Service Bulletin No. SB-AG-37
27 June 1994
 Page 1 of 12

CRACKS IN HORIZONTAL STABILIZER SPAR

MODELS AFFECTED:

MODIFIED CROSS-SECTIONAL VIEW - REPAIRED FRONT SPAR VIEW A

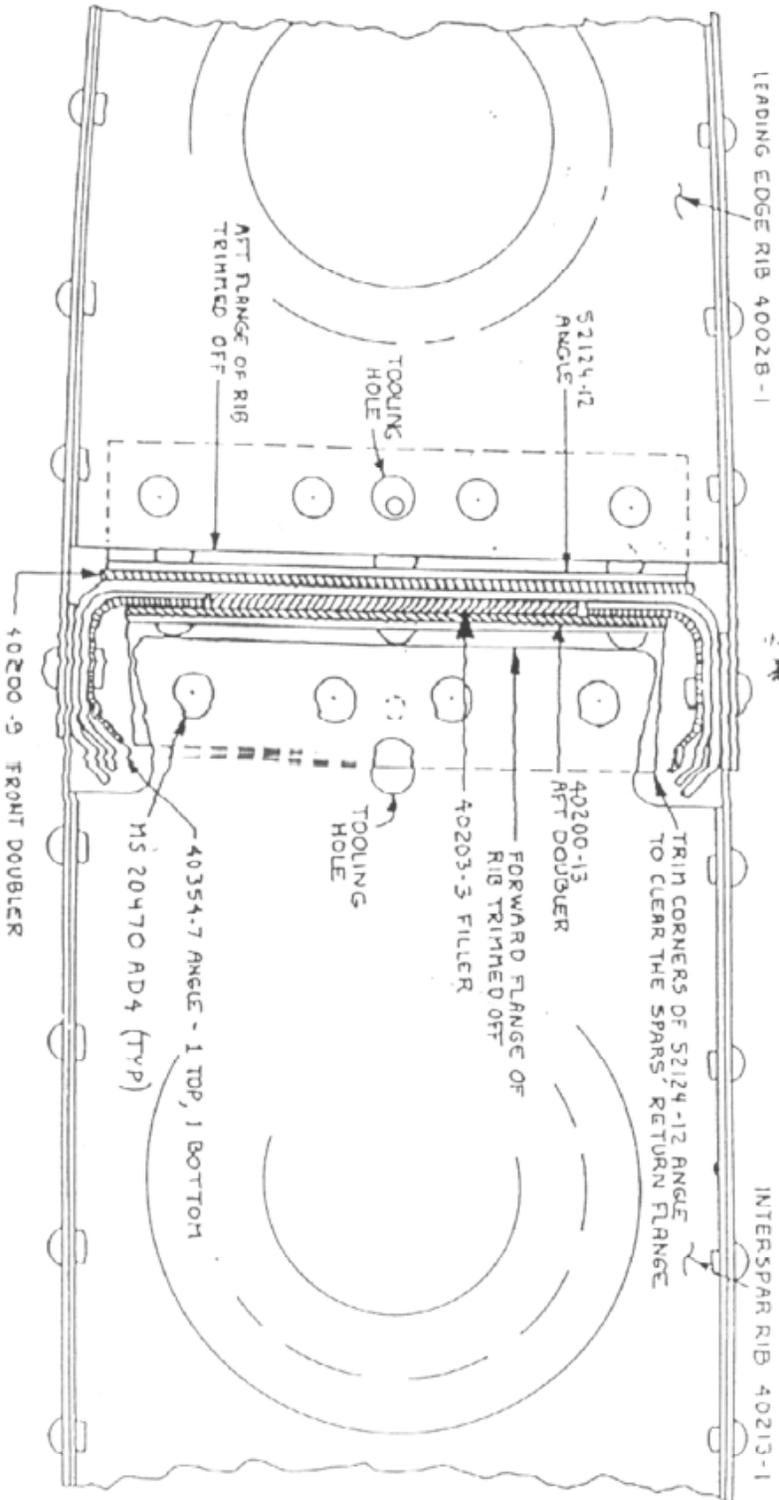
Front Spar Rework Ref View A & B, Pages 10 & 11

Drill off the 40200-1 aluminum spar doubler from the front face of the spar. Remove the two (upper and lower) 40354-1 nesting angles from the aft side of the spar. Drill out the rivets from the spar, for a distance sufficient to install the new nesting angles P.N. 40354-7.

Clamp the 40200-9 doubler to the front of the spar, being sure it is centered vertically and horizontally. The center attach holes (3/16) should be in the exact vertical center of the spar web. The height of the spar web should be $3.92 \pm .03$. The dimension from either edge will be 1.96 to the center. Clamp the 40354-7 angles in place, top and bottom. The angles must be nested firmly to the spar face and flanges.

Match drill the spar webs and the nesting angles' 3/16 holes, 18 places where the fittings attach bolts go through. Use a 3/16 diameter drill, then ream the four corner holes of the pattern to .189 and bolt the doubler down and the angles temporarily.

SHIM THE S2124-12 ANGLE AS NEED TO PREVENT THE RIVETS IN THE SPAR FROM BEING IN THE FLANGE RADIUS

ATTACH FITTINGS NOT SHOWN FOR CLARITY - SEE VIEW B ON PAGE 10 FOR FITTINGS.
